ADDENDUM NO. 1

Owner: City of Pasco
525 North 3rd Ave
Pasco, Wa 99301

Date: September 21, 2022
Project: Pasco Fire Station 85

REFERENCE SHEET:
A10.5

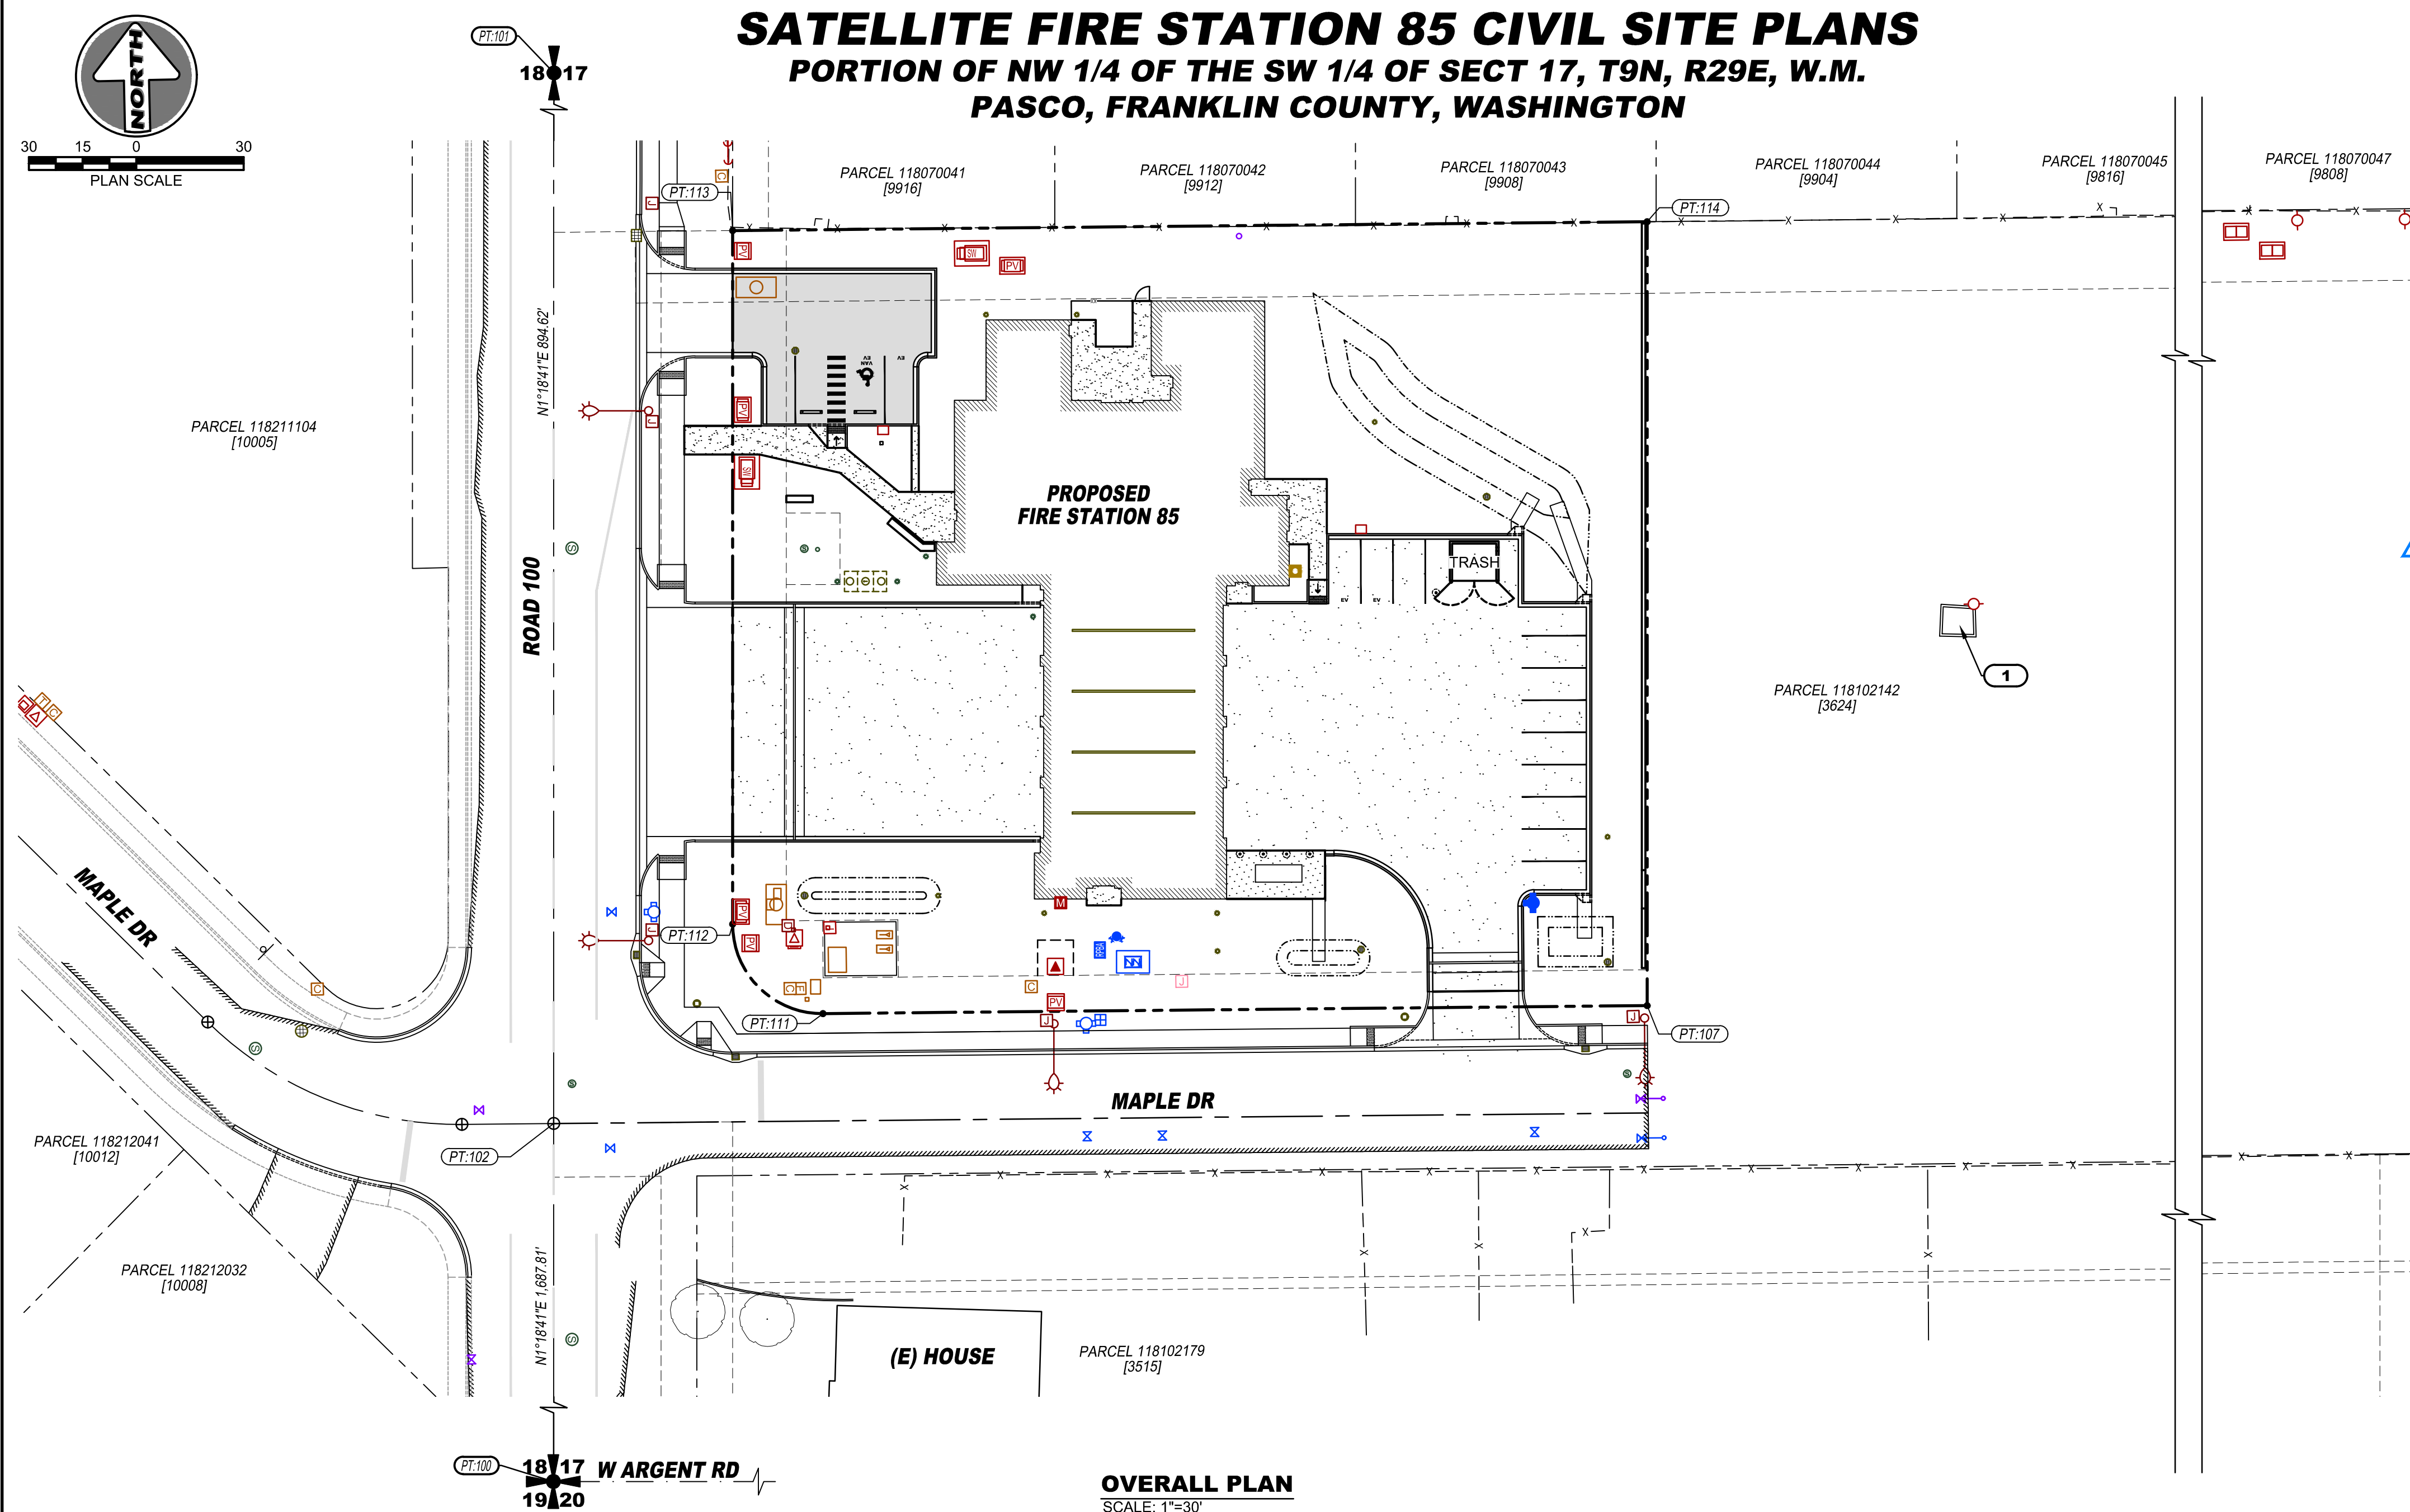
1. Refer to Sheet A4.2 Building Sections
 - a. Clarification: Refer to ADD-1 ASK 1 for revisions to detail 1/A4.2 E/W Section 4
2. Refer to Sheet A10.2 Exterior Details
 - a. Clarification: Refer to ADD-1 ASK 2 for revisions to detail 17/A10.2 Roof to Wall @ Chimney.
3. Refer to Sheet A10.4 Exterior Details
 - a. Clarification: Refer to ADD-1 ASK 3 for revisions to detail 14/A10.4 Fall Protection
4. Refer to Sheet A10.5 Exterior Details
 - a. Add: Refer to ADD-1 ASK 4 for added detail 7/A10.5 Mech curb – Grease Fan @ Chimney

Sheet Number: **C3.0**

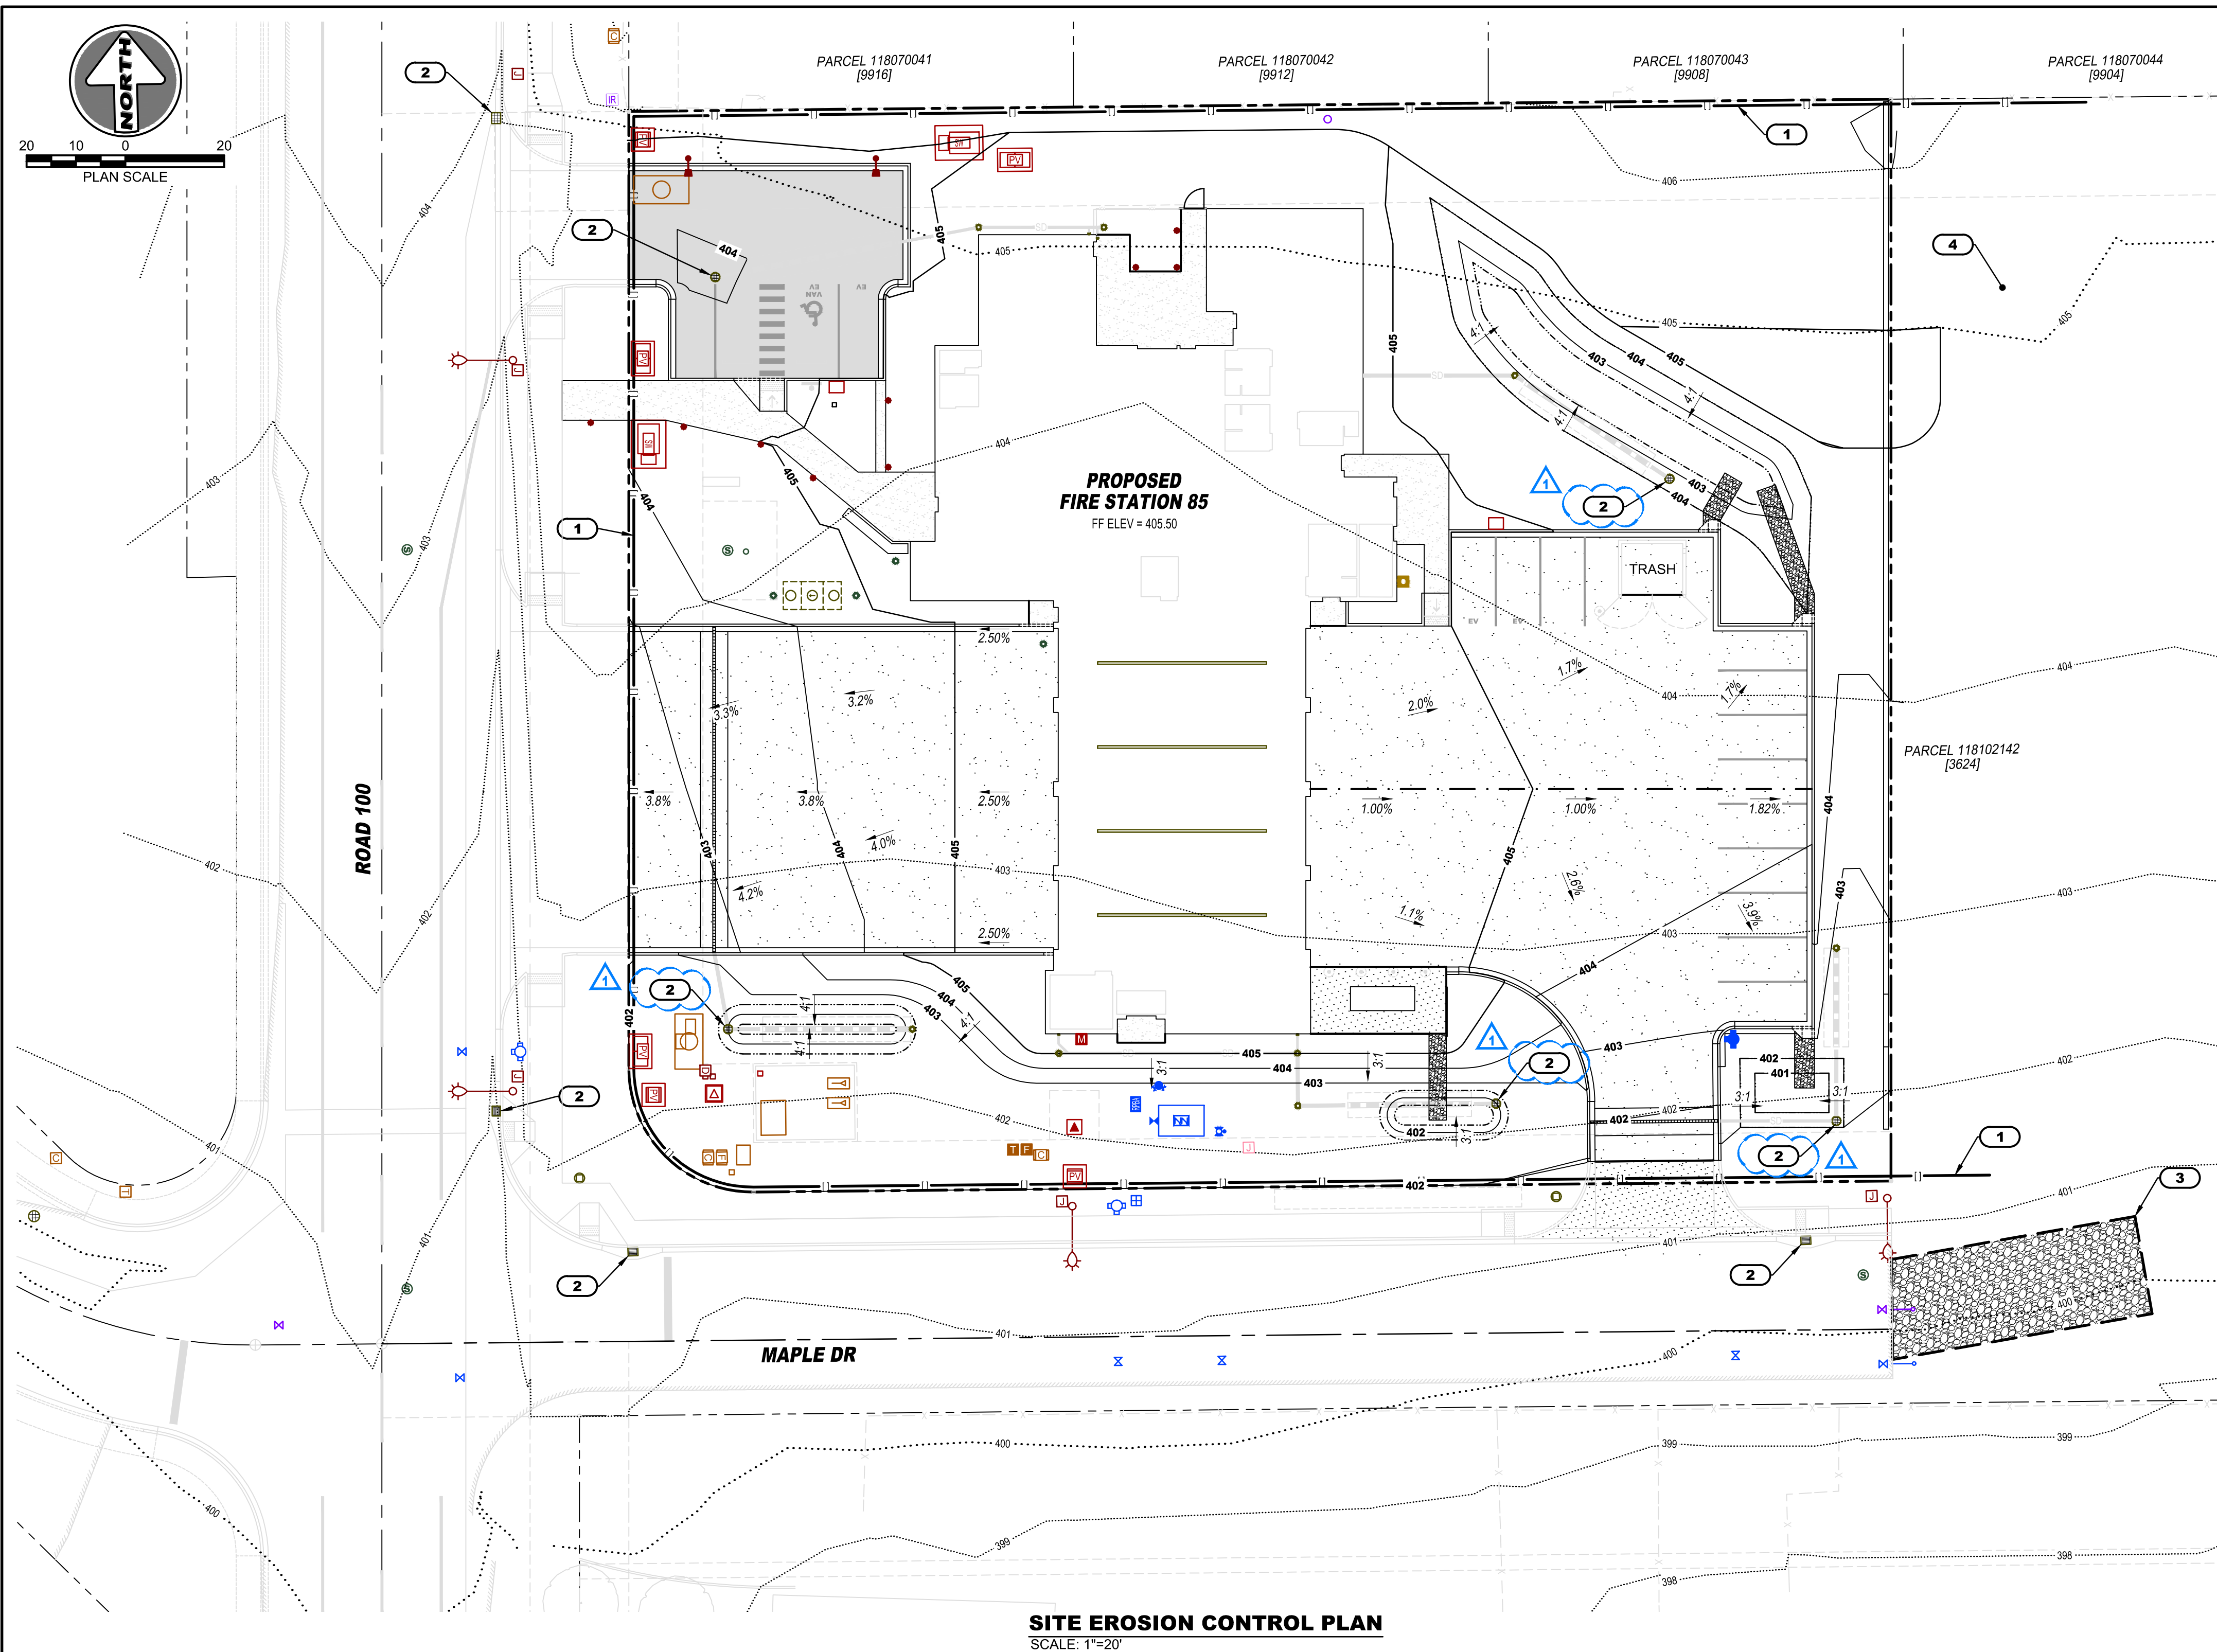
EQUIPMENT APPROVALS – CIVIL		
SECTION	ITEM	MANUFACTURER
C3.0	Polycast trench drain	ZURN
